DESIGNED - BJK		REVISIONS		
DRAWN - BJK	NO.	DATE	DESCRIPTION	
CHECKED - SL	1	03/28/2016	ADDENDUM NO. 1	
DATE - 2/5/2016

STATE OF ILLINOIS
DEPARTMENT OF TRANSPORTATION

ADVANCED DEMOLITION WORK

F.A.P. RTE.	SECTION	COUNTY	TOTAL SHEETS	SHEET NO.
10A	129-R-2-DM	JERSEY	12	2
CONTRACT NO. 76J48

F.A.P. RTE.	SECTION	COUNTY	TOTAL SHEETS	SHEET NO.
10A	129-R-2-DM	JERSEY	12	6
PARCEL 8T1S606		CONTRACT NO. 76J48		
PIN NO. 07-245-013-00

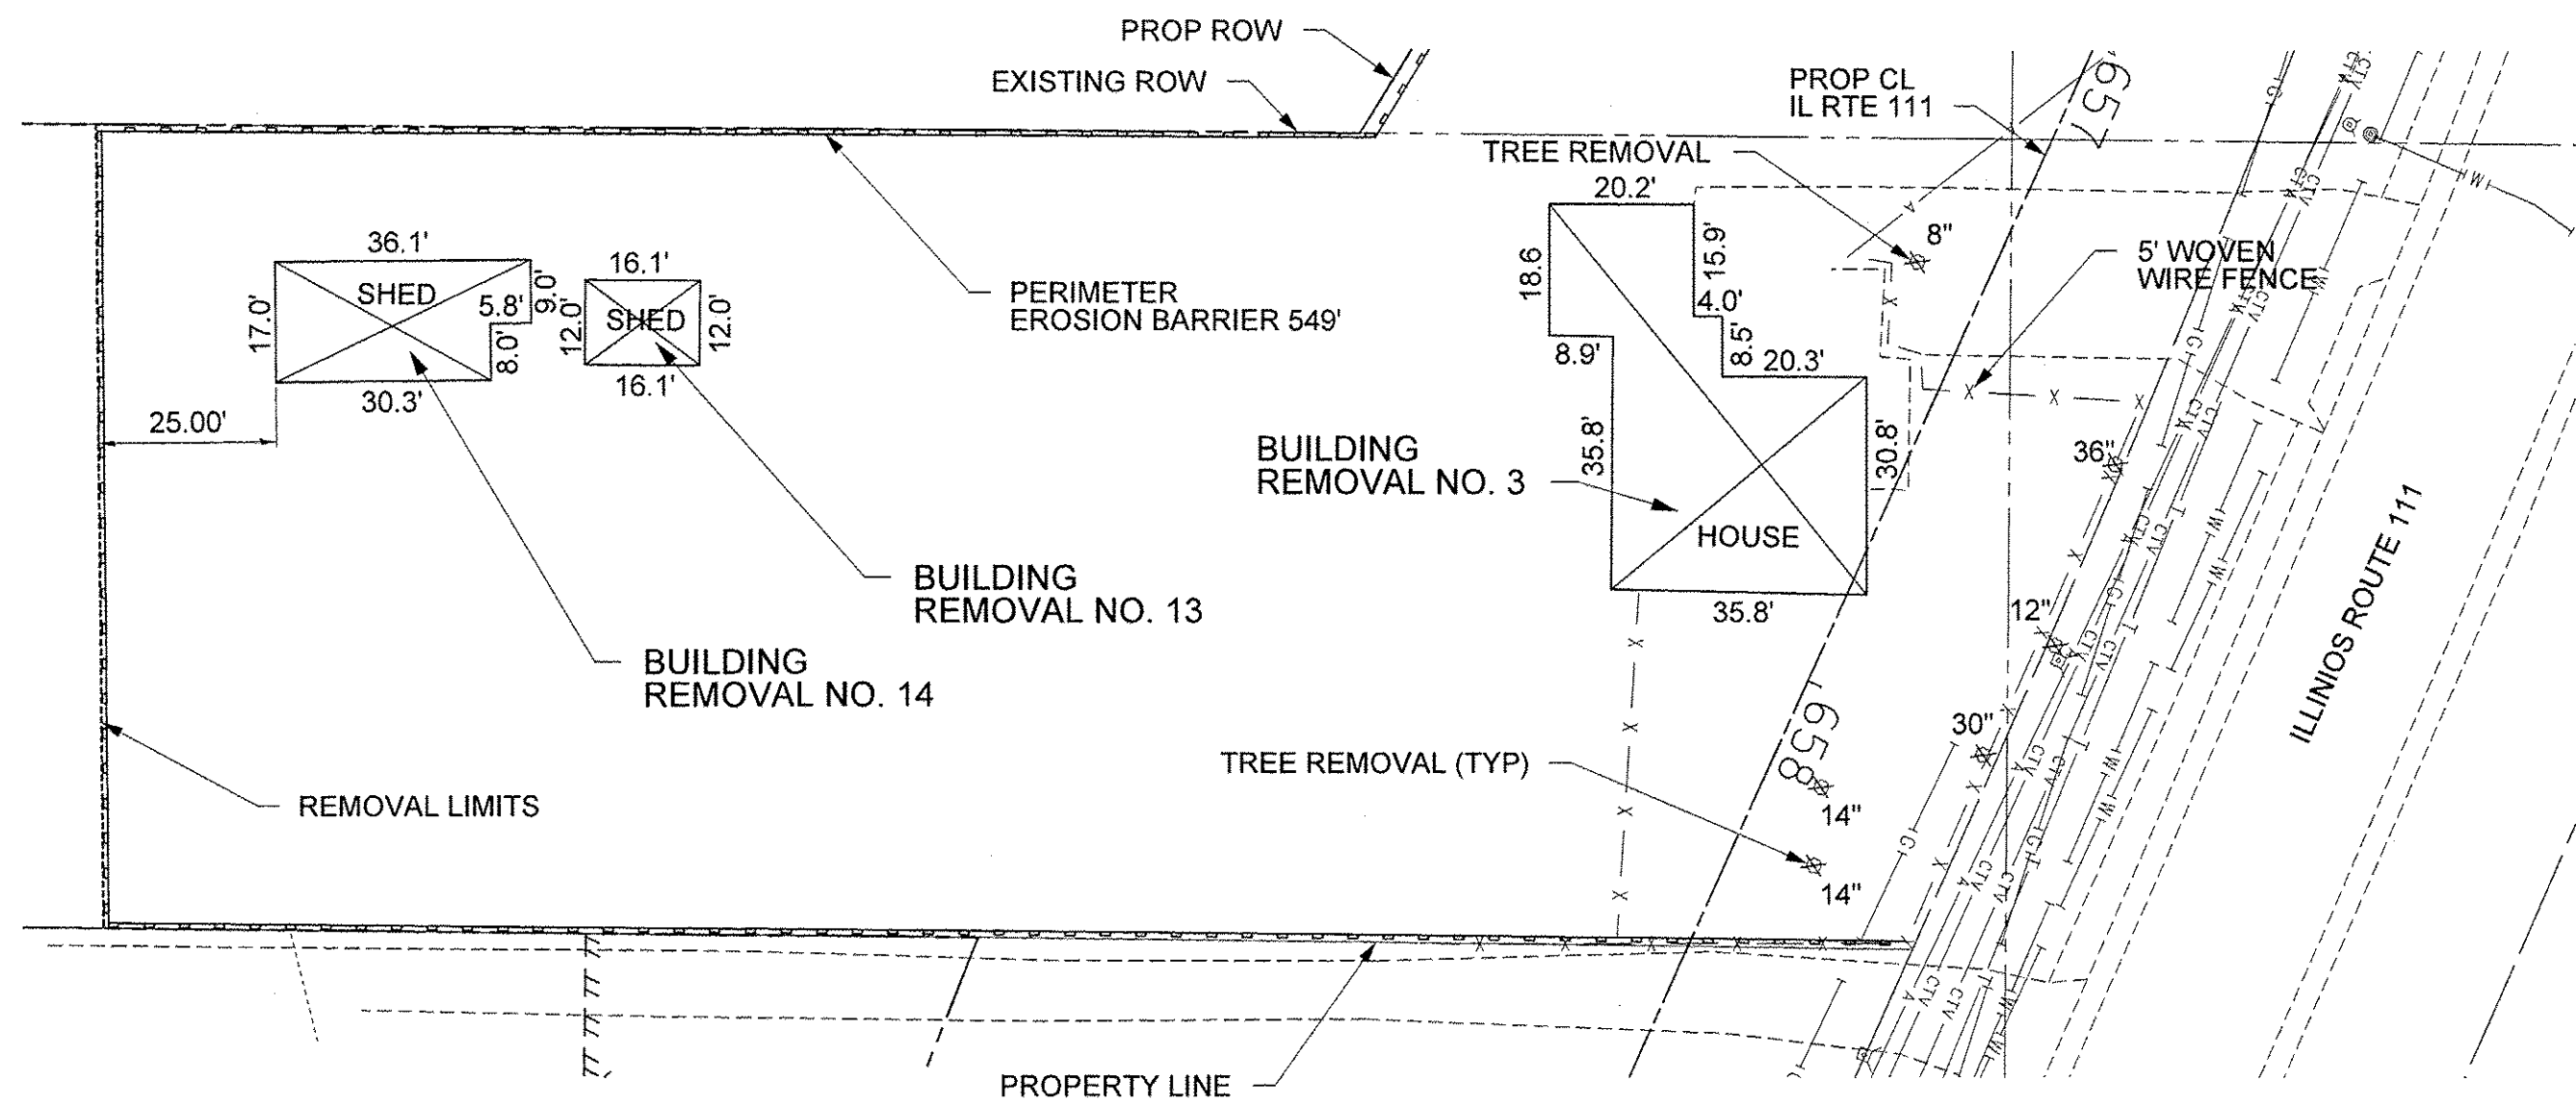
BUILDING REMOVAL
NO. 13
ONE STORY SHED

BUILDING
NO. 14
ONLE STORY SHED

1 ADDITION OF BUILDINGS 13 AND 14
REVISED SHEET 4-6-2016

EROSION AND SEDIMENT CONTROL PLAN

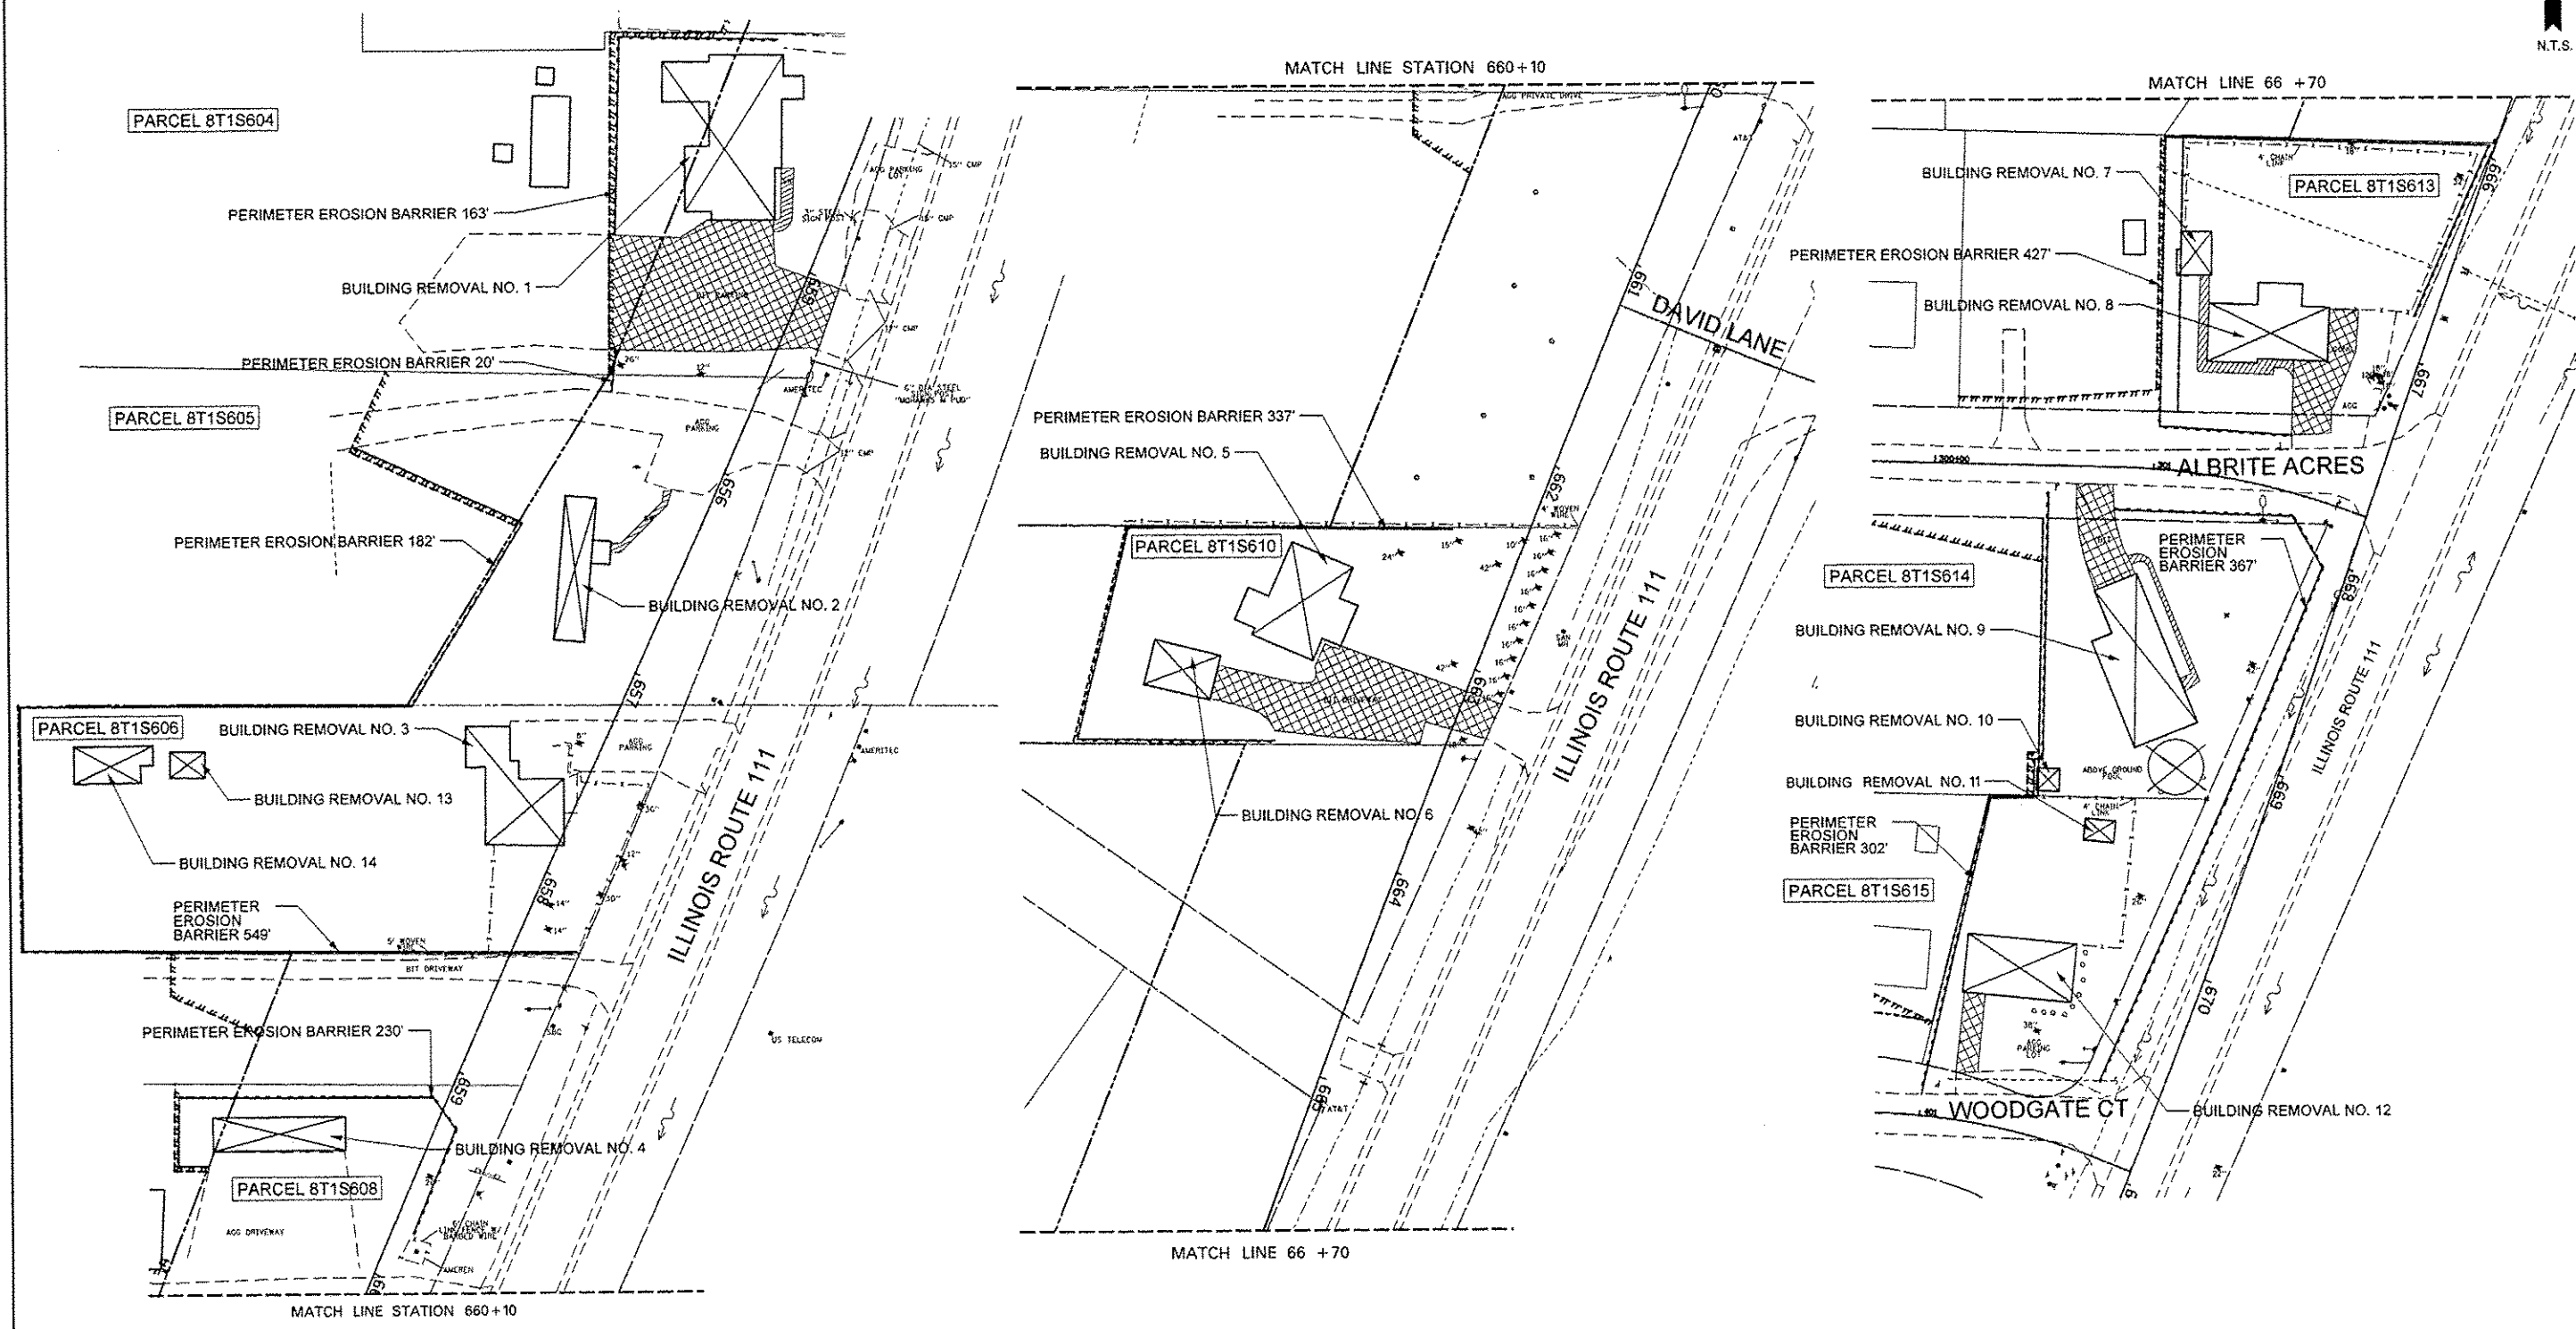
▲ ADDITION OF BUILDINGS 13 AND 14
REVISED SHEET 4-6-2016
